Corteco Service Information No. 00024-EN
www.corteco.com www.ecatcorteco.com

Service Information: **Oil seals redesigned and improved**

82036969 / 01036969B

0CS301457A

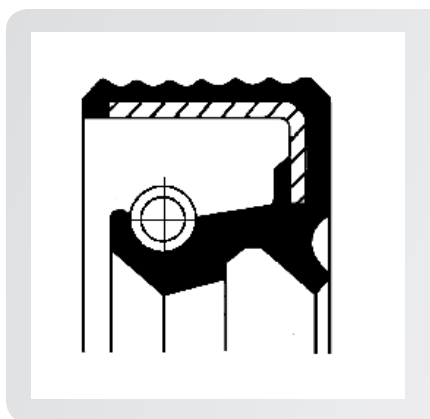
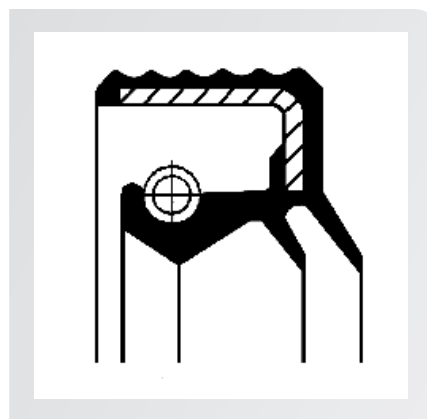
Radial shaft seal 01036969B has been redesigned with a double dust lip and is from now on available as radial shaft seal 82036969 to guarantee a better performance.

This functional improvement provides a better sealing action, whilst accomodating all the functions of the original radial shaft seal. Further information: www.ecatcorteco.com

Old seal without X6
Old Corteco No: 01036969B

New seal with X6 (double SL dust lip)
New Corteco No: 82036969
